# United States Patent and Trademark Office

APPLICATION NO.	FILING DATE	FIRST NAMED INVENTOR	ATTORNEY DOCKET NO.	CONFIRMATION NO.
10/719,478	11/21/2003	Takashi Suzuki	051319/0076	3623
7590 10/05/2005		EXAMINER		
Schulte Roth & Zabel, LLP			WOLFE, DEBRA M	
Intellectual Property Docketing 919 Third Avenue New York, NY 10022			ART UNIT	PAPER NUMBER
			3725	
			DATE MAIL PD. 10/05/0005

#### **DETAILED ACTION**

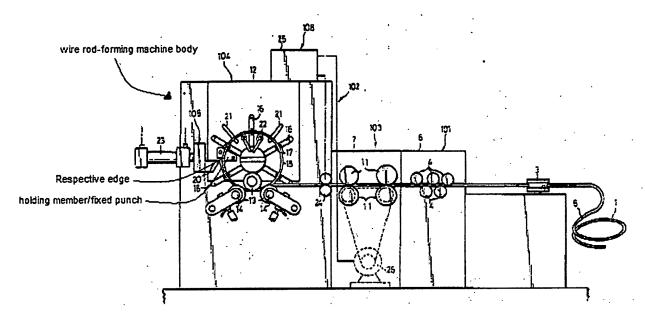
- 1. Claims 1-3 are rejected under 35 U.S.C. 102(b) as being anticipated by Yoshioka (U.S. Patent # 4,823,576). Yoshioka discloses an apparatus for manufacturing ring-shaped member from elongate work piece having a wire rod-forming machine body (See FIG below), bending rollers (13) for shaping a wire rod into a ring shape, a cutting member (cutting means 105) having a respective edge (blade 20) that moves in a horizontal direction in the wire rod-forming machine body and cuts the wire rod therefore separating the shaped part from the unshaped part, and a holding member/fixed punch having a respective edge (See FIG below) is crossed by the cutting member (cutting means 105) and allows the ring to be moved once it is cut by the cutting member (cutting means 105).
